RFB-2023-18

GLENDALE NURSING HOME KITCHEN AHU AND BASEMENT MECHANICAL ROOM VENTILATION

ADDENDUM #2

DRAWING TITLE FLUE DETAILS & **ENLARGED BOILER ROOM PLANS**

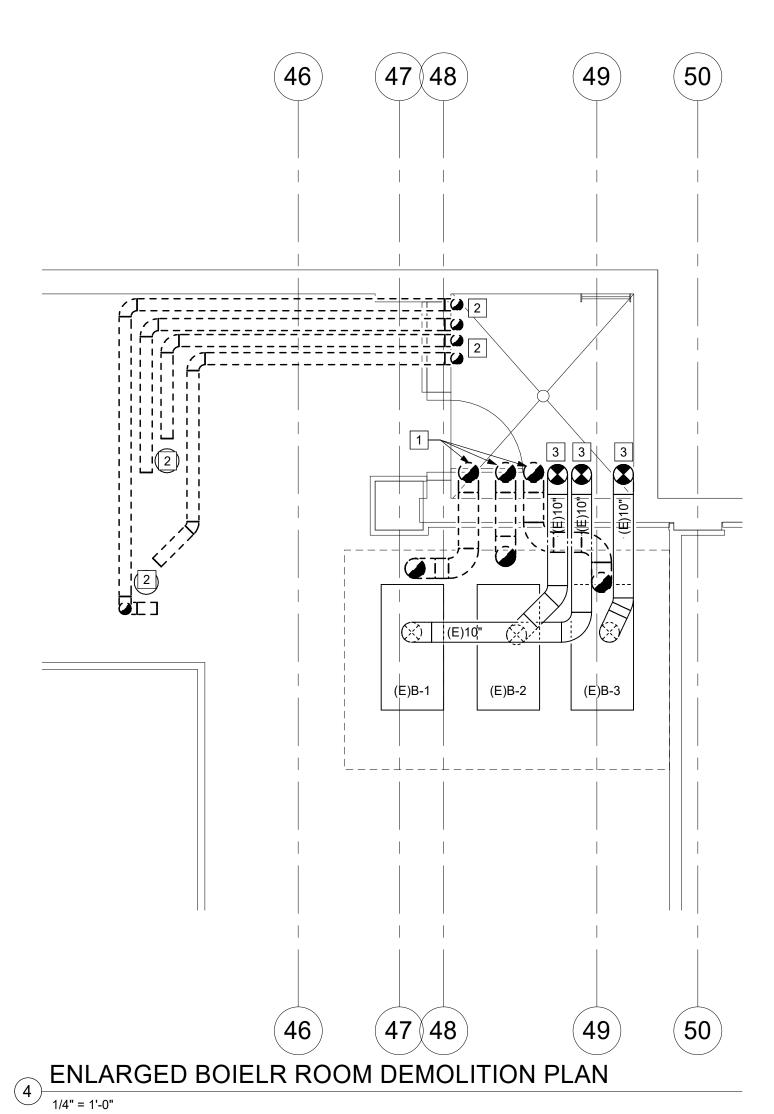
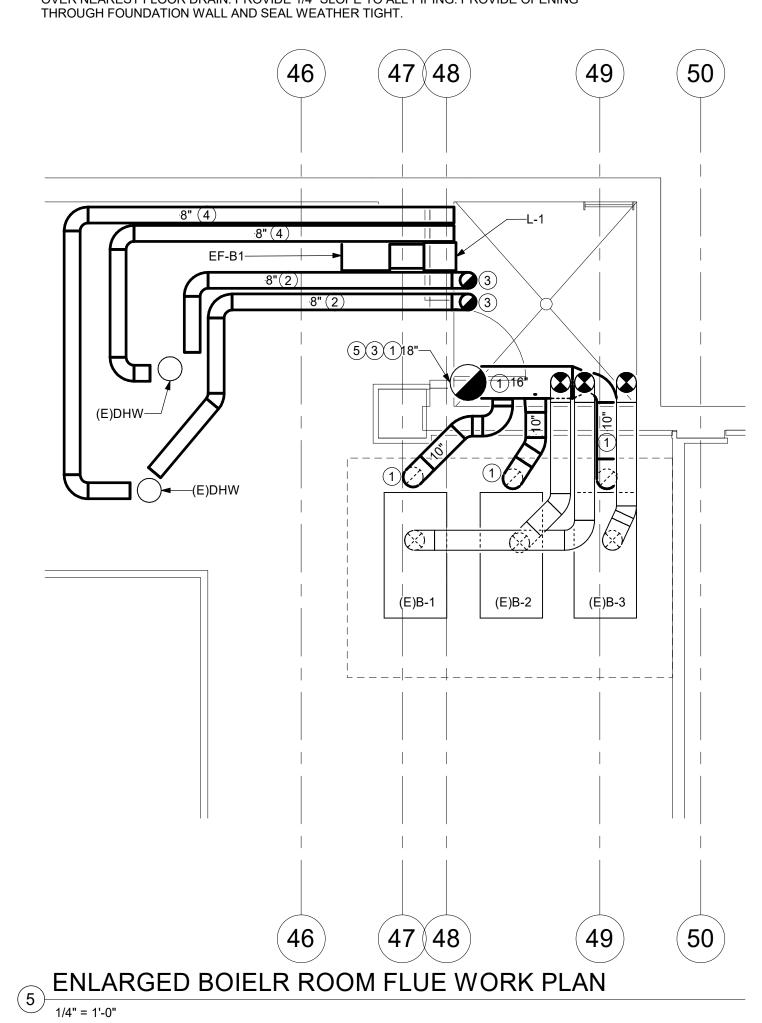
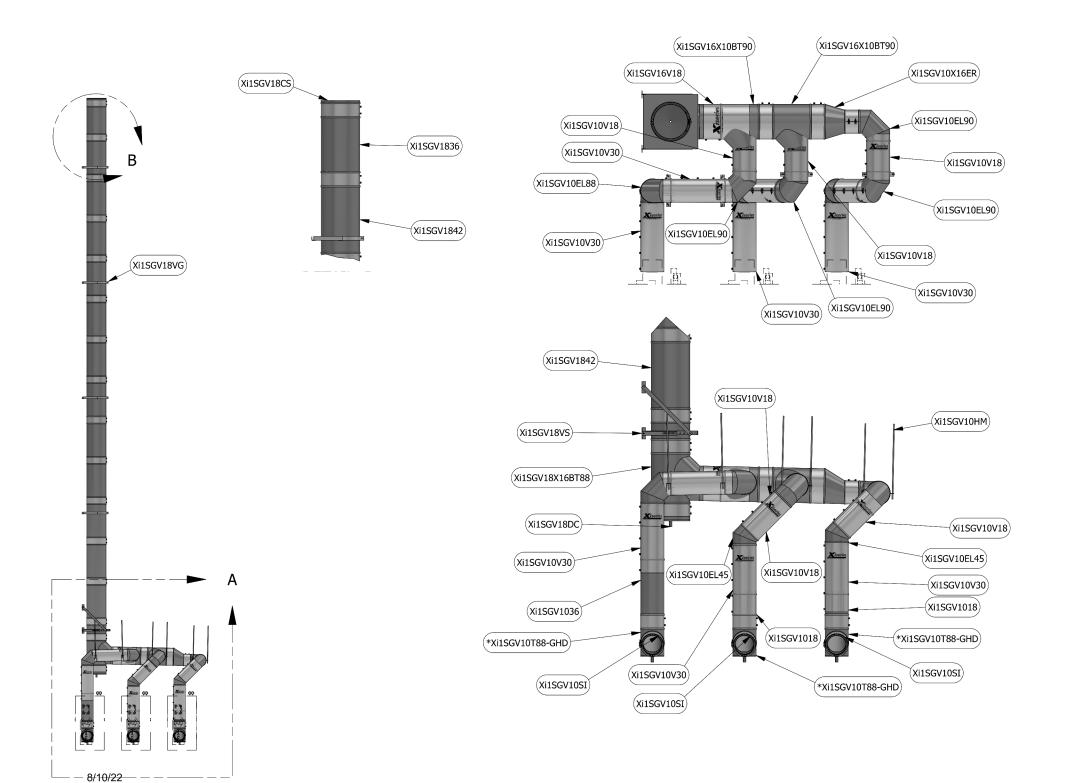
- A. Refer to Drawing No.: M-500 FLUE DETAILS AND ENLARGED BOILER ROOM PLANS
 - **REVISE** Drawing Notes keynote 2 to read: "PROVIDE 8" POLYPROPYLENE 1. **SOLID** CORE **FLUES** PER **MANUFACTURERS** INSTALLATION INSTRUCTIONS. FOLLOW ROUTING OF EXISTING FLUE. SLOPE FLUE BACK TOWARDS WATER HEATER. SUPPORT FLUE OFF OF CHIMNEY **PENETRATIONS** STRUCTURE. SEAL ALL **WEATHER** TIGHT. POLYPROPYLENE FLUE SHALL BE UL S636 LISTED. BASIS OF DESIGN DURAVENT POLYPRO OR EQUAL."
 - 2. REPLACE drawing in its entirety with drawing dated December 19, 2022.

1 REFER TO DETAILS 1,2,3/M-500 FOR MORE INFORMATION. SUPPORT FLUES OFF OF CHIMNEY STRUCTURE PER MFG INSTALLATION INSTRUCTIONS. PROVIDE OPENINGS AS ~~REGUREDTHROUGHFOUNDATION_3EALALDPENETRATIONS_WEATHER,TIGHT;~~~~ 2 PROVIDE 8" POLYPROPYLENE SOLID CORE FLUES PER MANUFACTURERS INSTALLATION INSTRUCTIONS. FOLLOW ROUTING OF EXISTING FLUE. SLOPE FLUE BACK TOWARDS WATER HEATER. SUPPORT FLUE OFF OF CHIMNEY STRUCTURE. SEAL ALL PENETRATIONS WEATHER TIGHT. POLYPROPYLENE FLUE SHALL BE UL S636 LISTED. BASIS OF DESIGN DURAVENT POLYPRO OR EQUAL.
